MKDP Outline Pre-Application Queensbury Lane, Monkston Park Plots 10 &12

Pre - application Report from Development
Management

Application no: 14/01836/PREMED

**At: Plots 10 And 12, Queensbury Lane,
Monkston Park, Milton Keynes,**

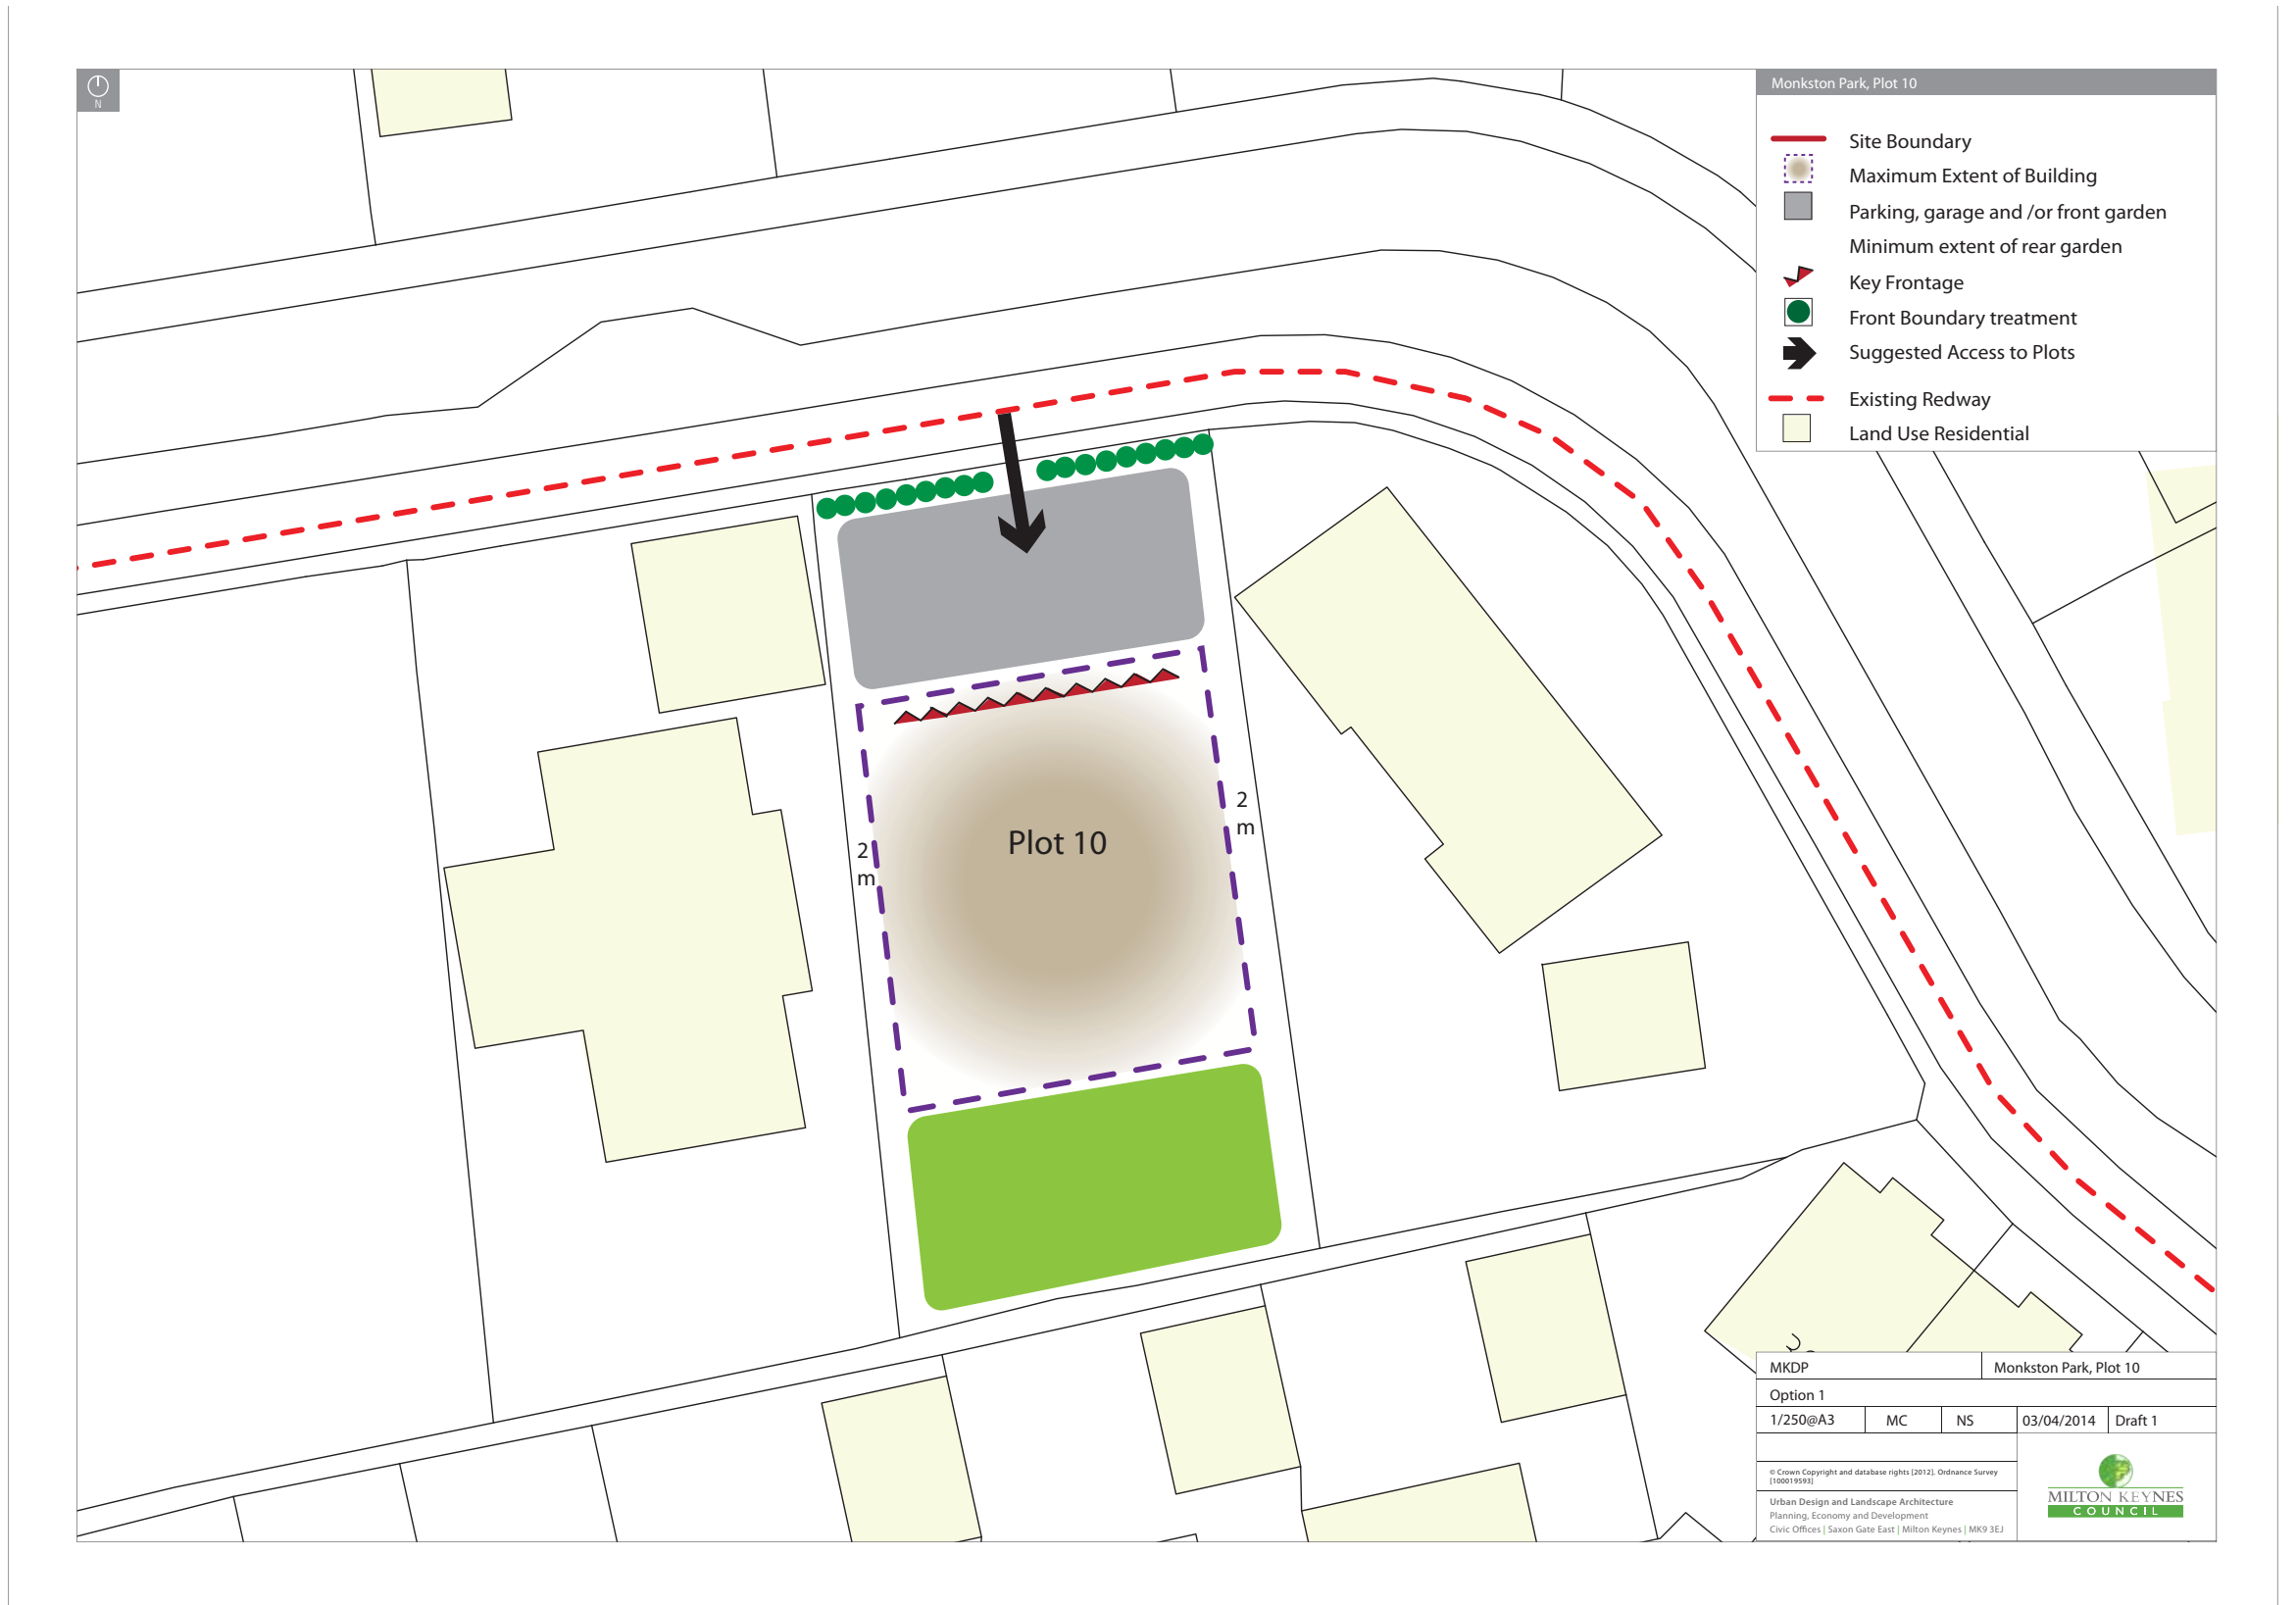
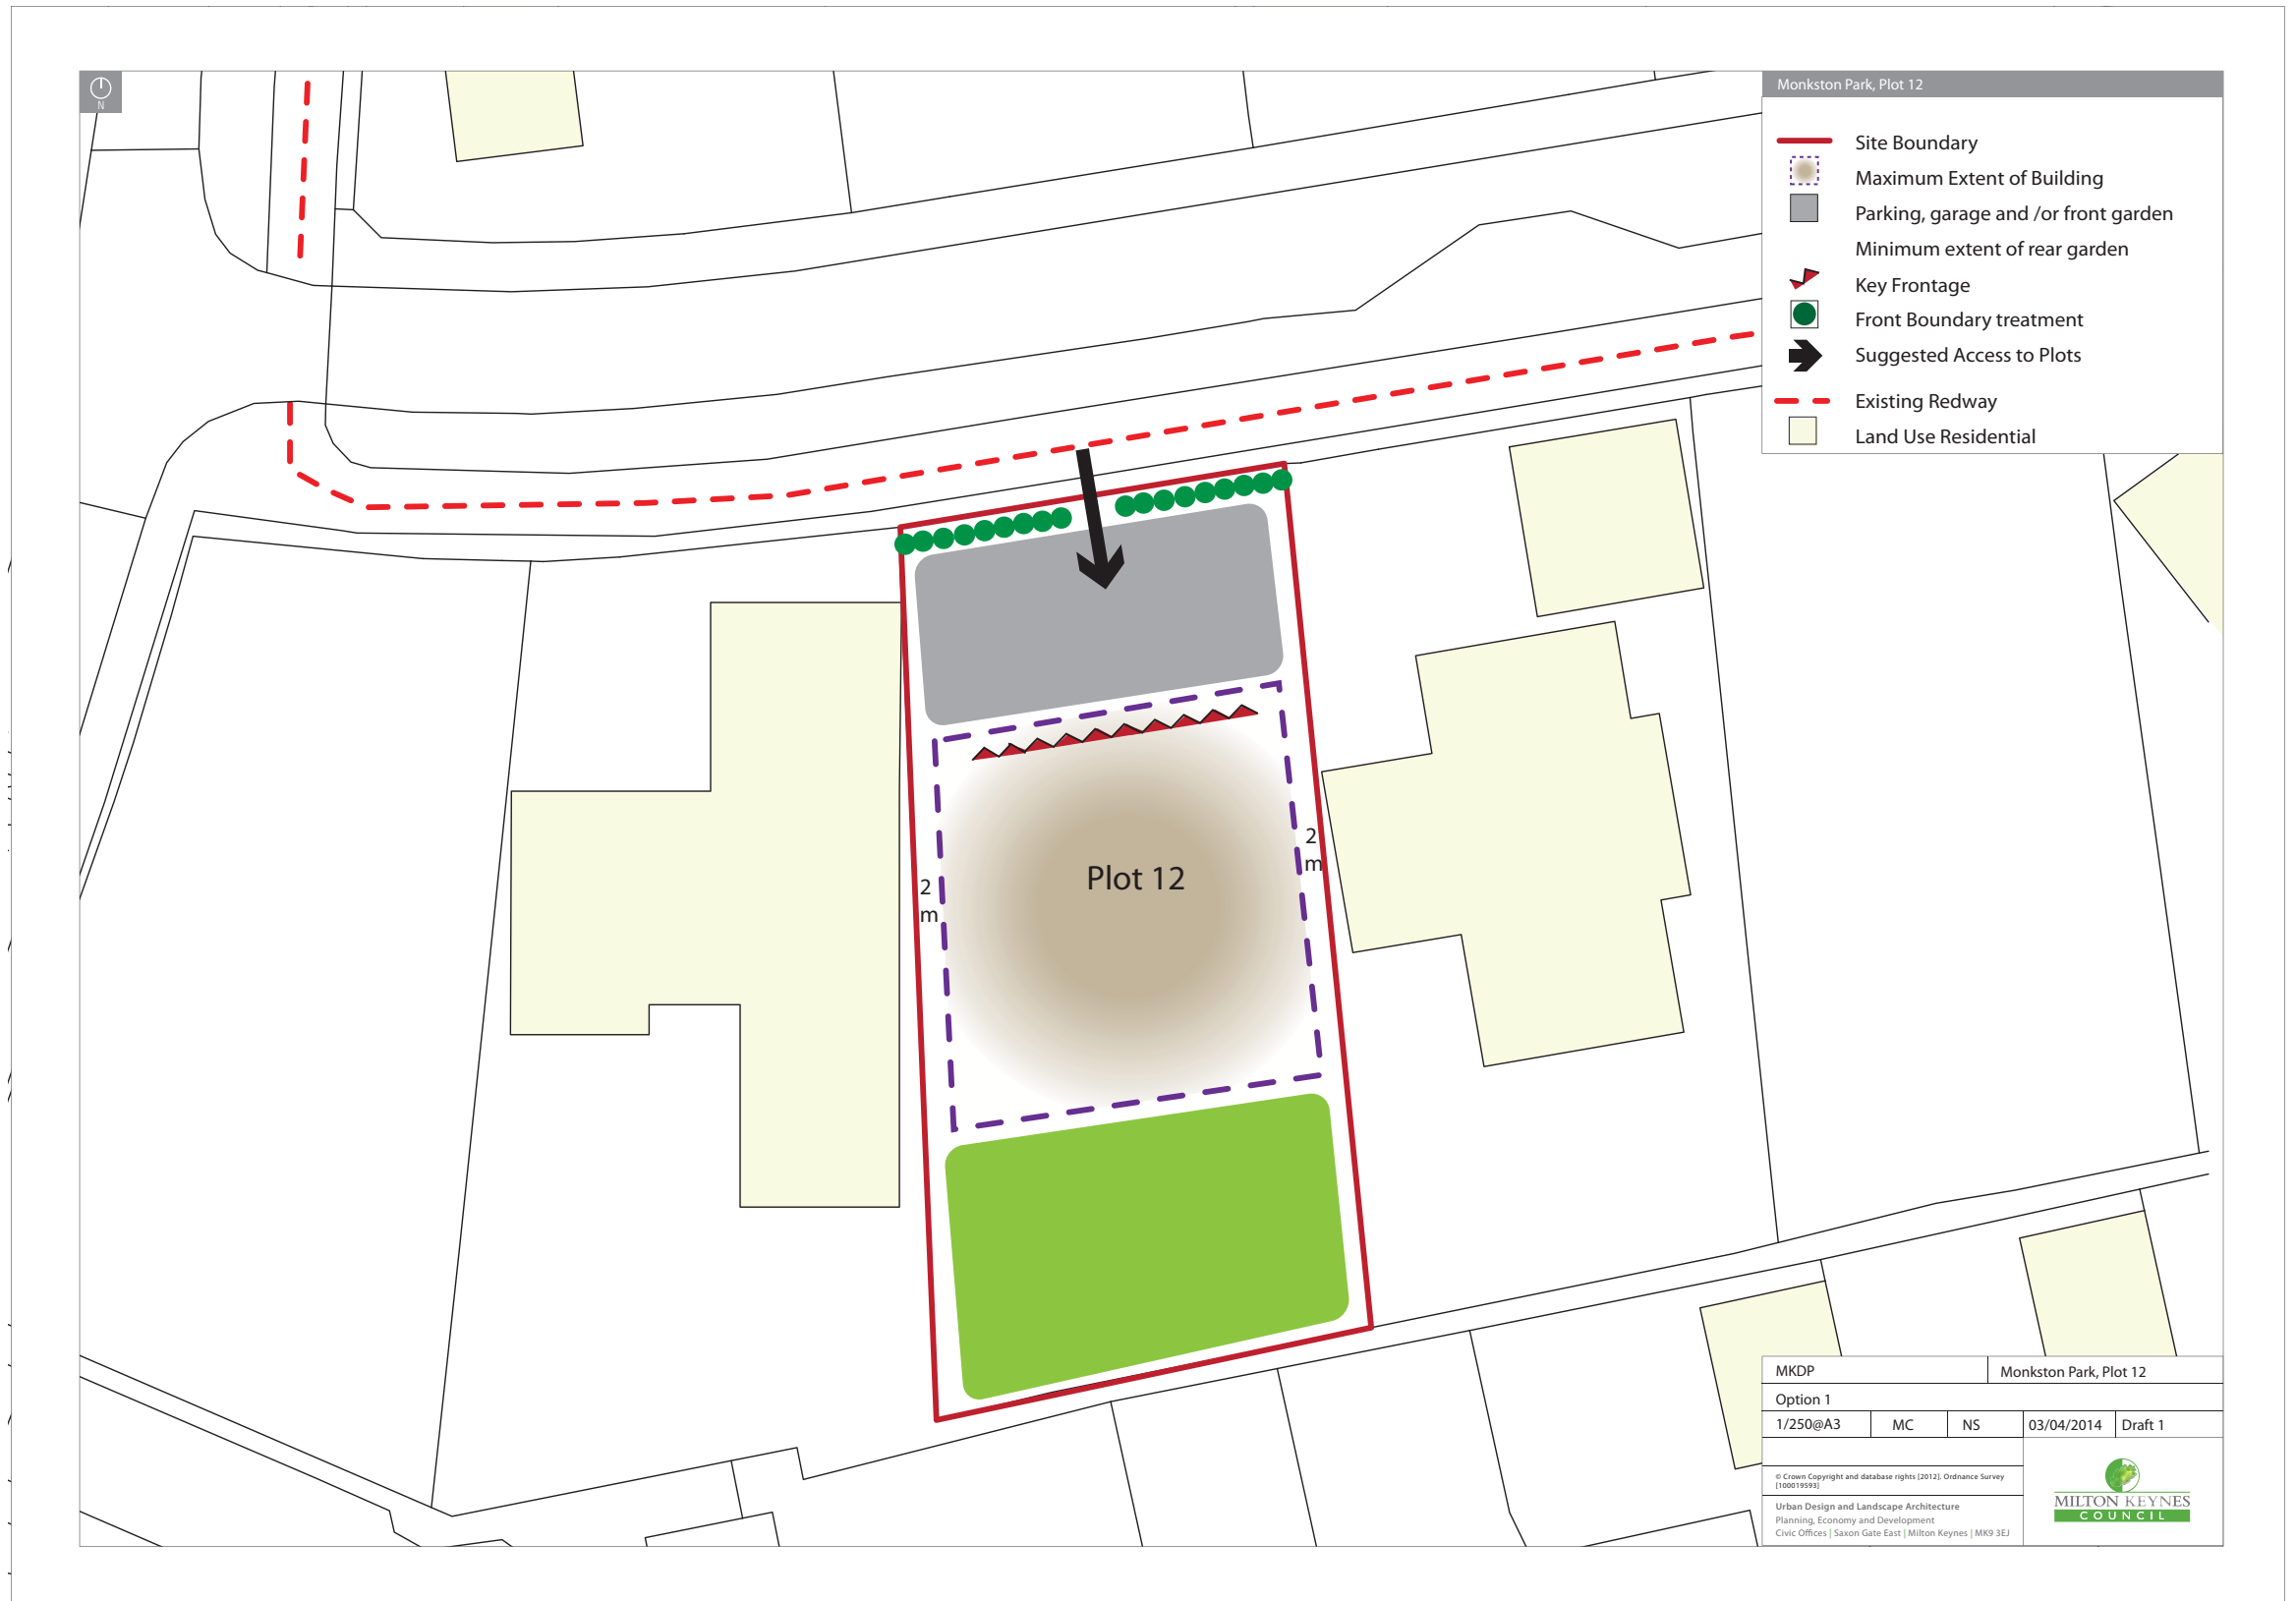
Landscape Architect: "The site contains a good mature hedge/tree line along the south boundaries, but this is not shown on the layout constraints.

The hedge/trees add maturity, will have some ecological benefit & provides a buffer from the adjacent housing.

The brief must recognise the hedge/trees; specify retention & state protection during construction works."
